Re: Chevron Service Station No. 9-0020
5280 Hopyard Road
Pleasanton, CA

Re: Work Plan for Soil Vapor Survey
Chevron Service Station 9-0917
5280 Hopyard Road
Pleasanton, California
ACEH RO #0439

Subject: Fuel Leak Case No. RO0000439 and Geotracker Global ID T0600100345, Chevron #9-0917, 5280 Hopyard Road, Pleasanton, CA 94566

Subject: Fuel Leak Case No. RO0000439 and Geotracker Global ID T0600100345, Chevron #9-0917, 5280 Hopyard Road, Pleasanton, CA 94566

Proposed Soil Vapor Probe Locations

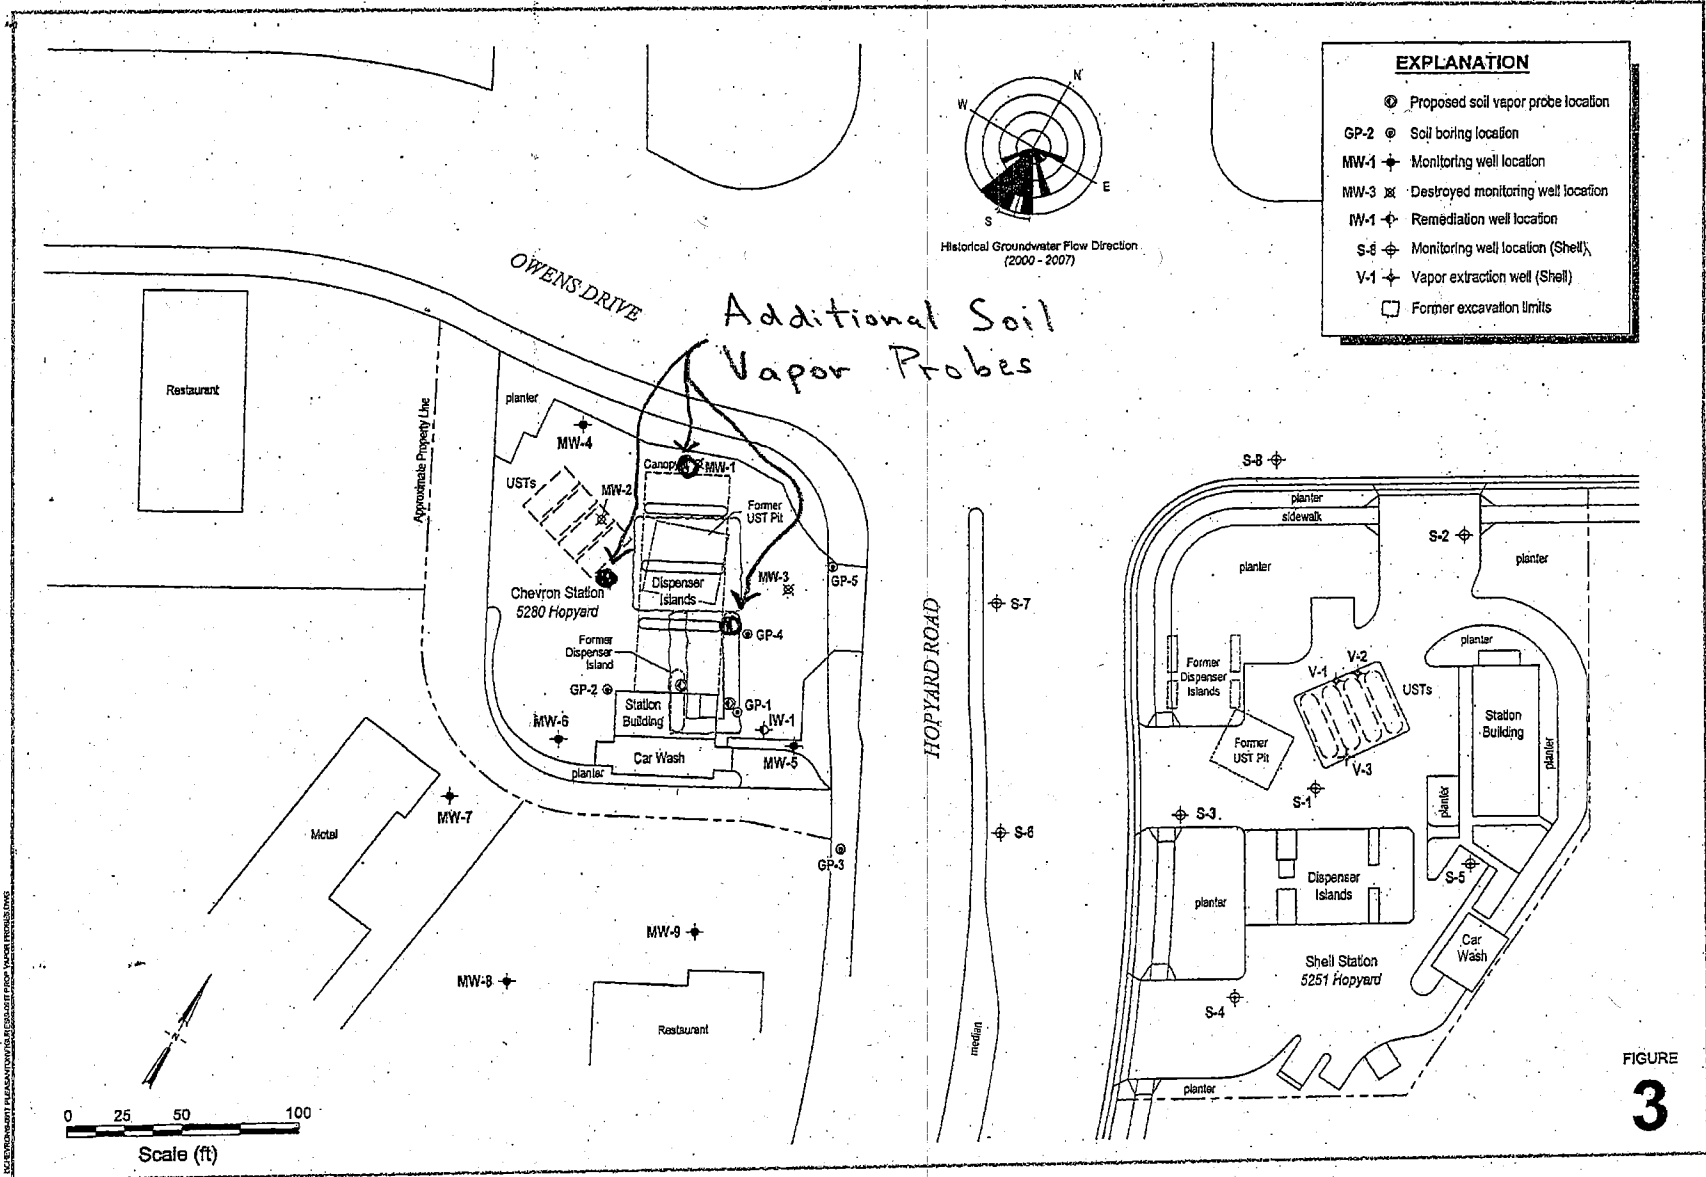
1. **Soil Vapor Probes.** The "Response to Technical Comments and Workplan for Installation of Vapor Probes," proposes the installation of two soil vapor probes adjacent to the existing service station building. Although the two proposed soil vapor probe locations address the potential for indoor vapor intrusion for the existing facility, the potential for indoor vapor intrusion must be evaluated for potential future land use as well. Therefore, we request that three additional soil probes be installed at the locations shown on Attachment 1. Please present results from the soil vapor probe installation and sampling in the Soil Vapor Investigation Report requested below.
